Addendum #: Addendum #3
Issue Date: 03/29/2024

Job #: 8-22-01-011 Edgar County Jail
 TBD SPRINGFIELD RD
 PARIS, Illinois 61944

EDGAR COUNTY PUBLIC SAFETY CENTER
 EDGAR COUNTY, ILLINOIS
 12636 950TH ROAD
 PARIS, ILLINOIS 61944
21003.003

1 LIGHTING MEZZANINE PLAN - JAIL
 1/8" = 1'-0"

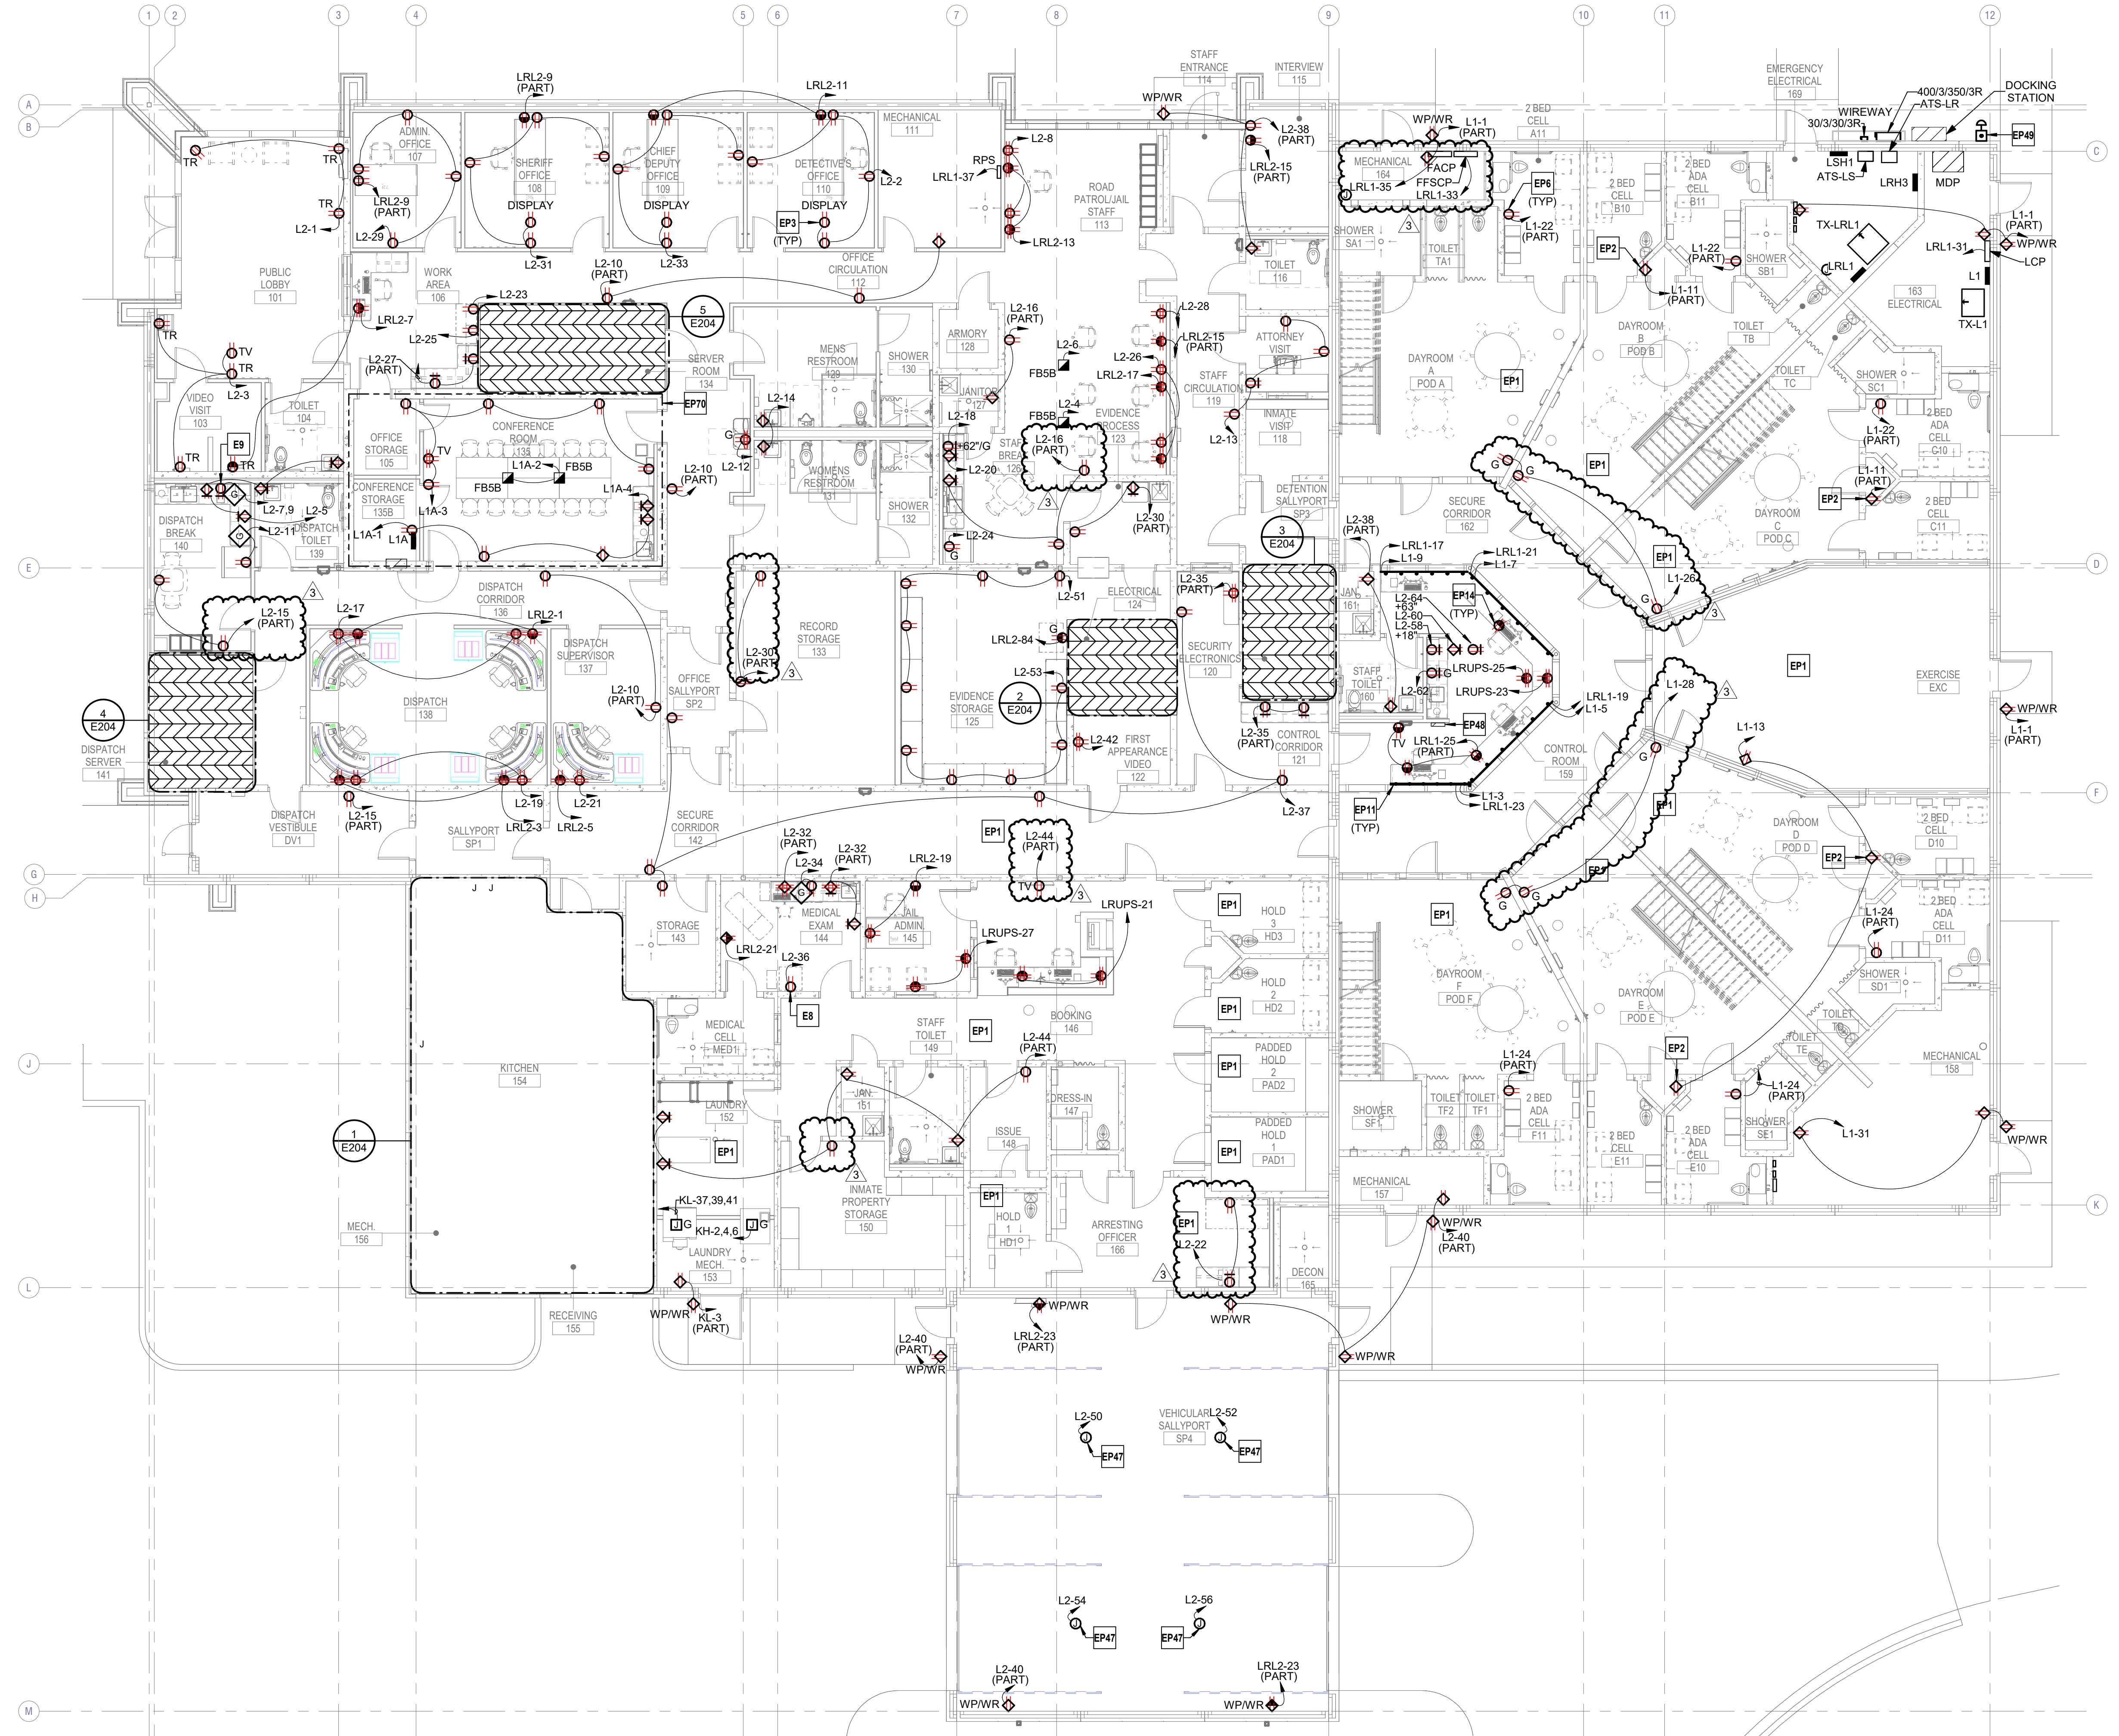
1. SHEET E102 - LIGHTING MEZZANINE PLAN – JAIL
 - A. Relocated and added exterior light.
2. SHEET E201 – POWER FIRST FLOOR PLAN - OVERALL
 - A. Added receptacle in Record Storage room 133.
